<https://www.emnrd.nm.gov/ocd/contact-us/>State of New Mexico
Energy, Minerals and Natural ResourcesForm C-103
Revised July 18, 2013OIL CONSERVATION DIVISION
1220 South St. Francis Dr.
Santa Fe, NM 87505

SUNDRY NOTICES AND REPORTS ON WELLS
(DO NOT USE THIS FORM FOR PROPOSALS TO DRILL OR TO DEEPEN OR PLUG BACK TO A DIFFERENT RESERVOIR. USE "APPLICATION FOR PERMIT" (FORM C-101) FOR SUCH PROPOSALS.)

Wellname: **Leonard State #2**

Operator: MEWBOURNE OIL CO P.O. Box 5270 Hobbs, NM 88241	OGRID: 14744
	Action Number: 379872
	Action Type: [C-103] NOI Plug & Abandon (C-103F)

Leonard State #2 WBS

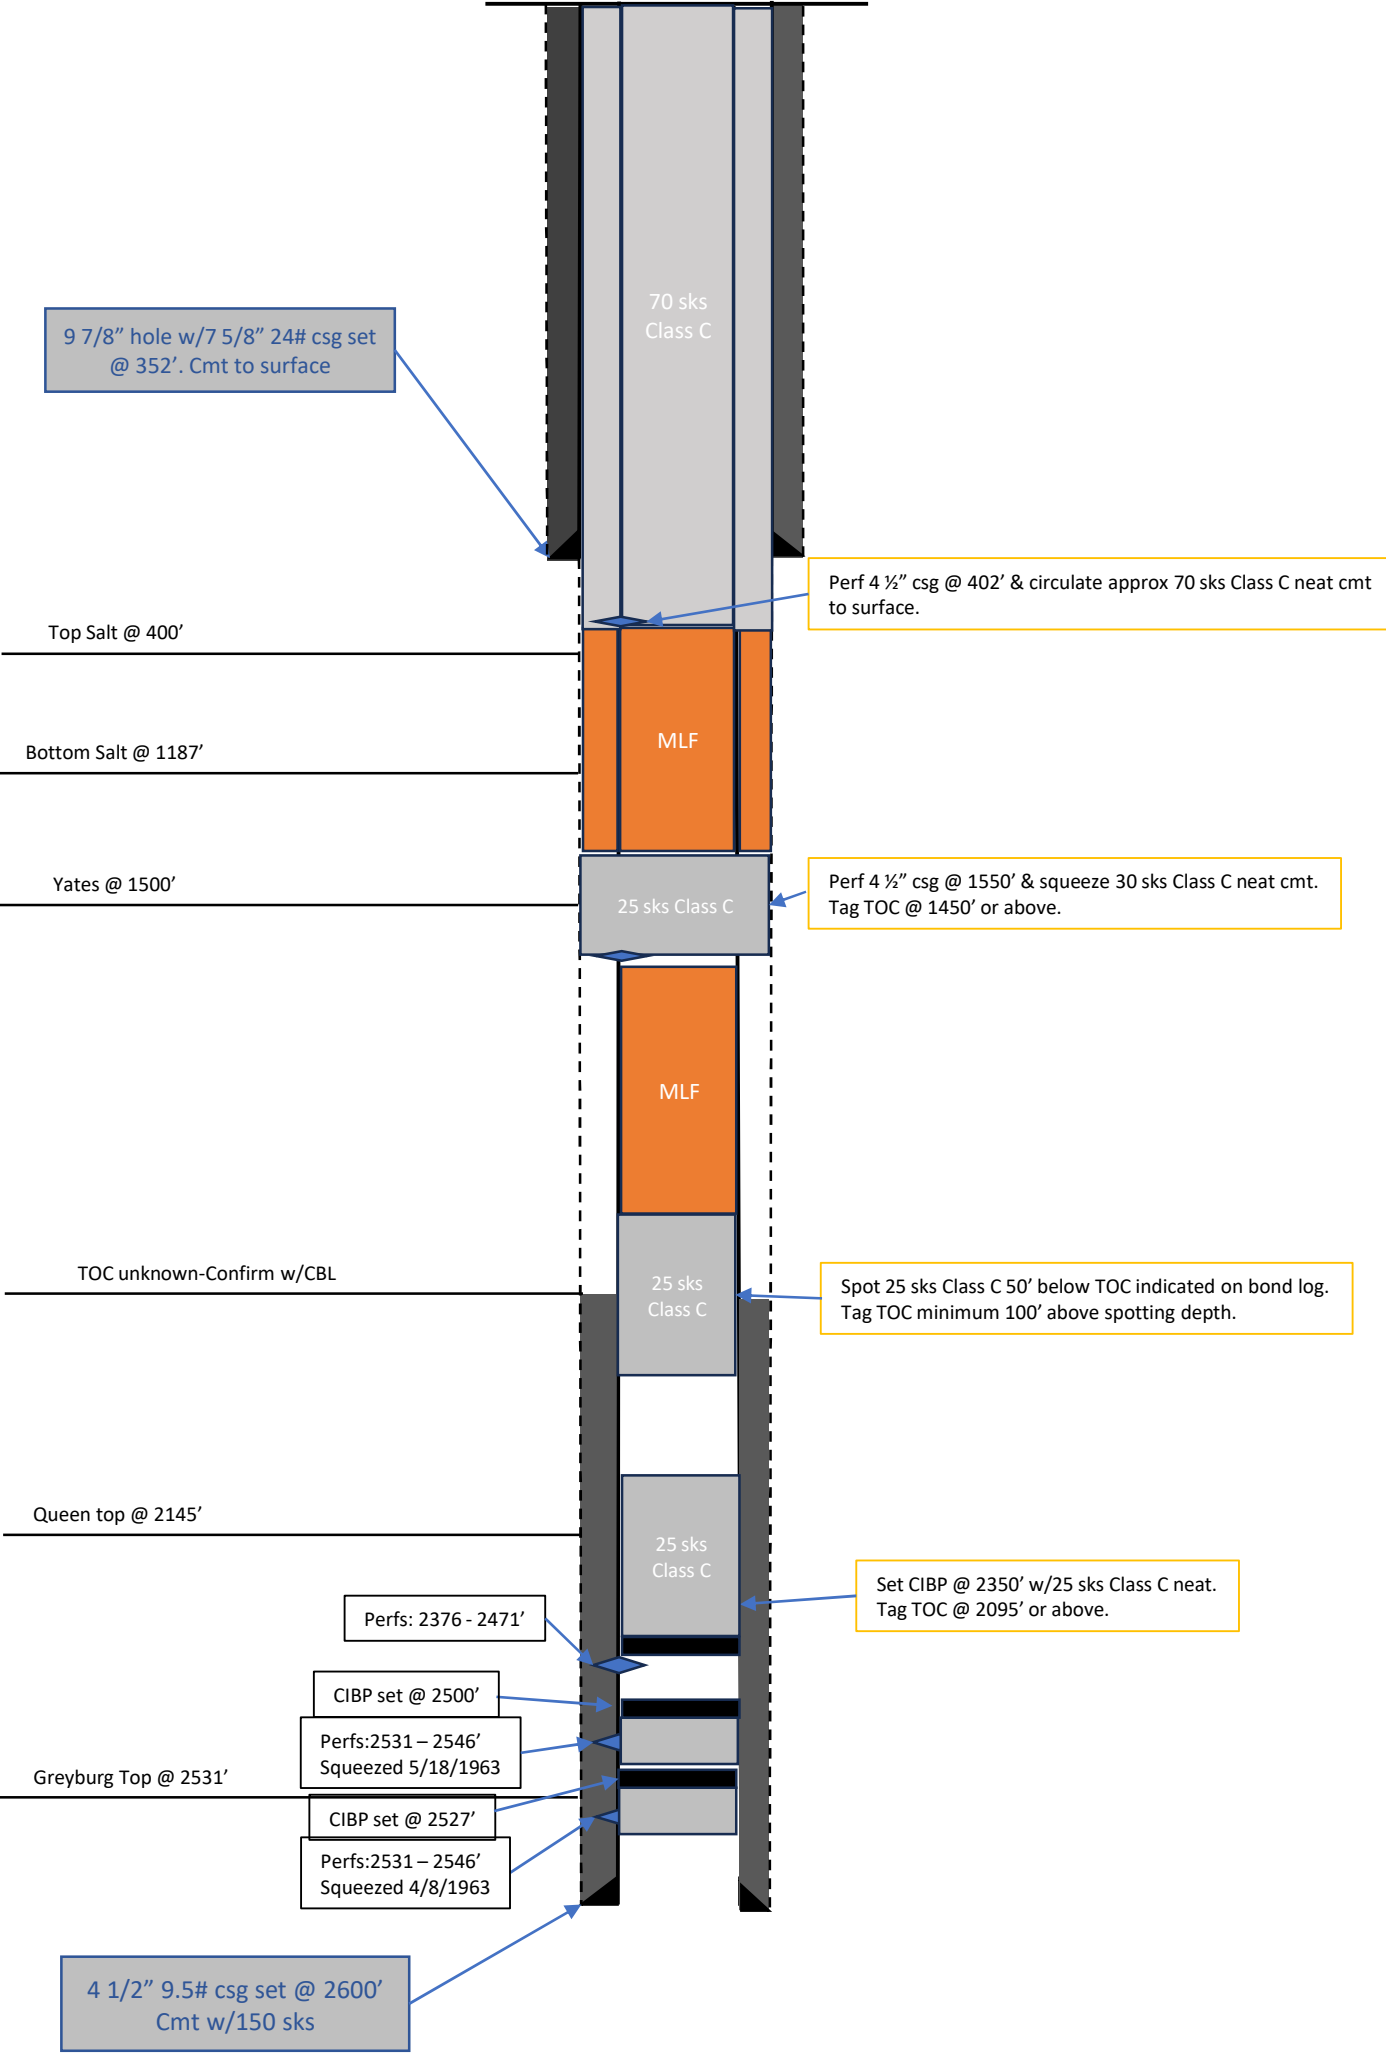
Created By	Condition	Condition Date
loren.diede	Notify NMOCD 24 hours prior to beginning p&A operations.	9/19/2024
loren.diede	Submit CBL into NMOCD Imaging via Electronic Permitting.	9/19/2024
loren.diede	Add plug for the Base of Salt, perforate at 1237', pump inside /outside plug from 1237' to 1137'.	9/19/2024
